核四廠高壓爐心灌水系統設備製造 品質證明文件查證報告

行政院原子能委員會

核四廠 HPCF 系統設備製造品質證明文件查證報告

圖二 HPCF 泵殼與泵筒相對位置圖

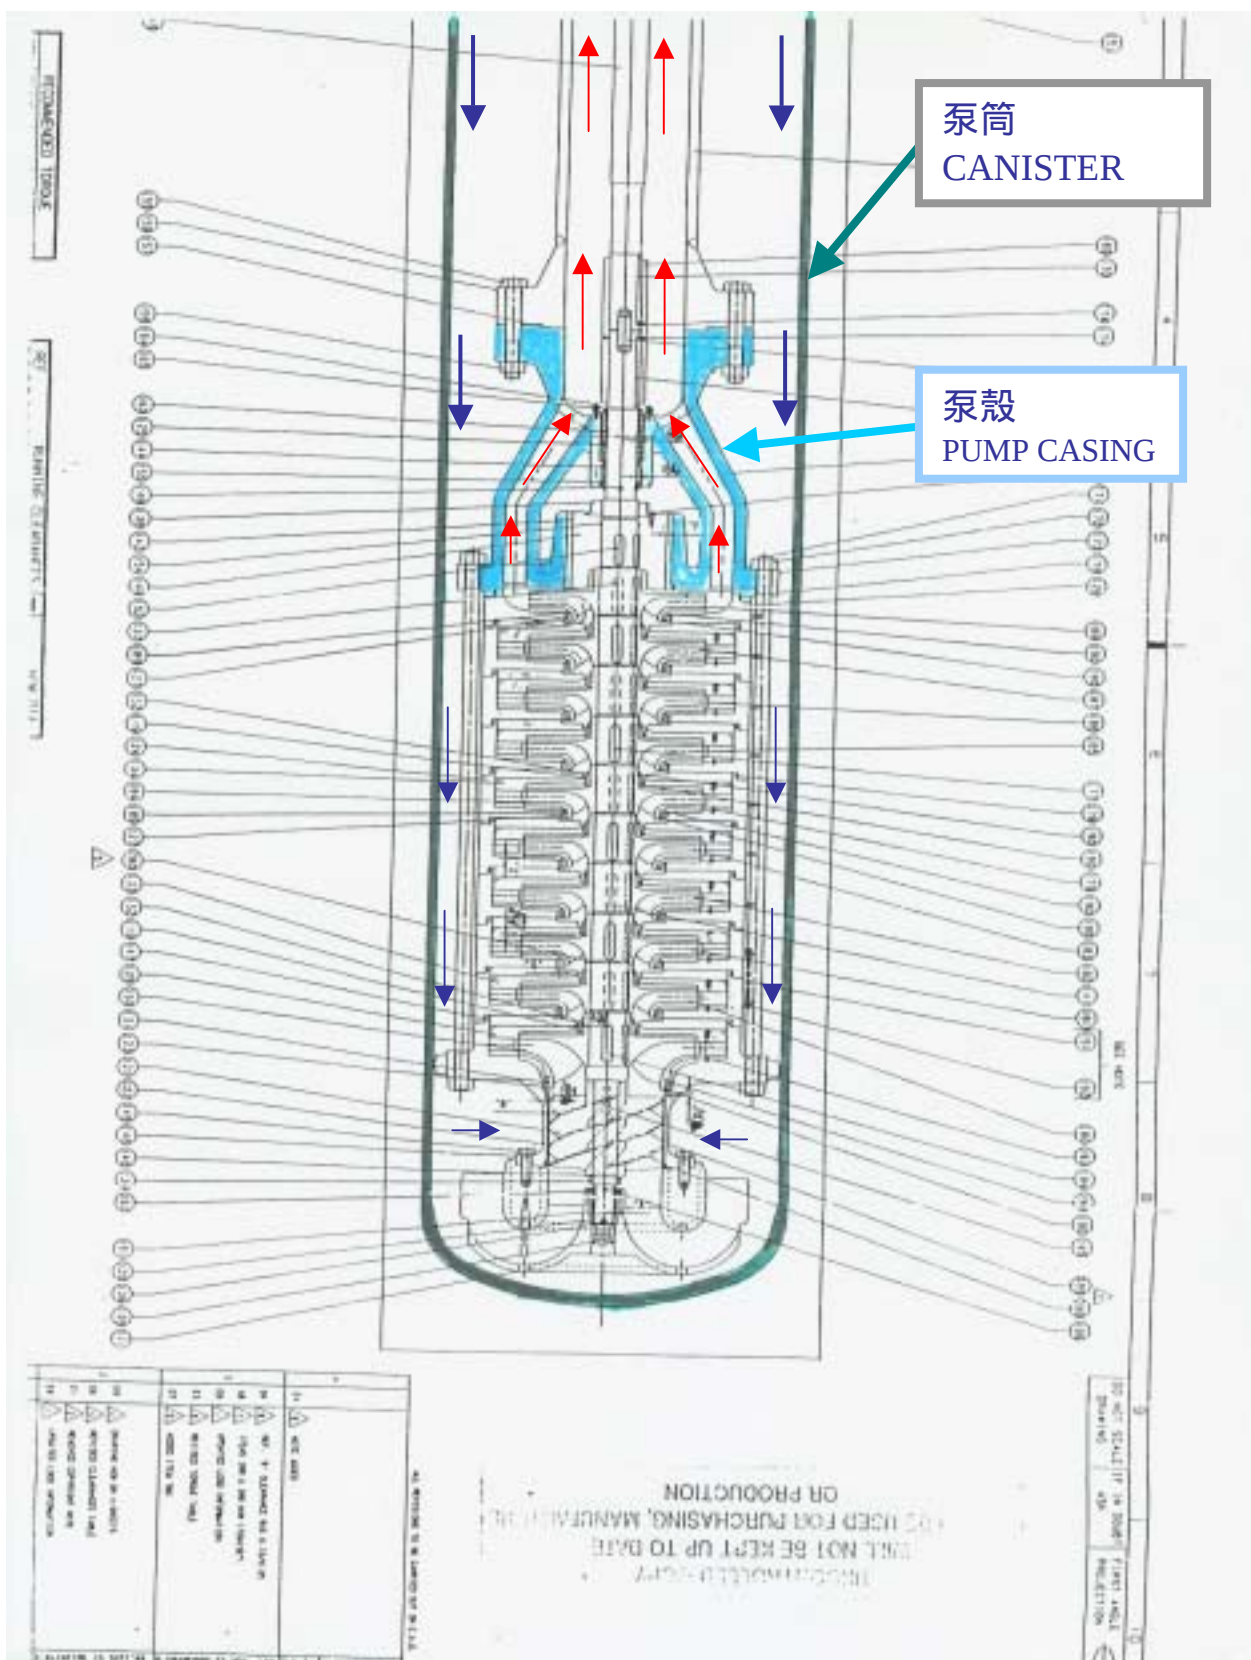
- (1) 經查閱 HPCF 泵各組件之材質證明，PUMP CASING (HEAT No. 及 s/n 分別為 1758 A01、1910 A02、1910 A03 及 1964 A04) 部分共有四件，在其材質證明首頁上所標示之 Material Specification/Grade 欄位為 ASME SA216 WCB 及 ASME class 2 (如附件三)，製造方式為鑄造，但後續個別之 PUMP CASING 材質分析表單上卻列出其係 ASME class 3 材質 (如附件四)，而查閱其後附之檢測記錄亦是依據 class 3 鑄件要求僅執行磁粒檢測 (MT)，與 class 2 鑄件 (4 吋以上) 法規要求之 RT 或 UT 檢測不符。此項差異，經核安處駐龍門品保小組立即告知核安處，並與奇異公司聯繫要求澄清疑點，經奇異公司查證說明該組件並非泵之壓力邊界，故雖然 HPCF 泵整體係屬 ASME class 2，但 PUMP CASING 係 HPCF 泵內部組件，故係使用 class 3 材料，但奇異公司亦承認 PUMP CASING 材質證明首頁上所列之 CLASS 2 係誤植。奇異公司之說法，經要求施工處提供相關圖面討論結果，確認 HPCF 泵之設計在最外層尚有泵筒 (CANISTER，如附圖二)，而 PUMP CASING 係位於泵筒內部，因此確實非泵之壓力邊界，此外在其製造圖

面亦將此組件列為與 ASME CODE 無關之組件。此案經與相關人員討論，確認奇異公司之說明可以接受，但品質文件存在之差異，台電公司仍應要求奇異公司等相關單位改正，以避免未來設備使用期間查閱品質文件時，再度造成混淆。
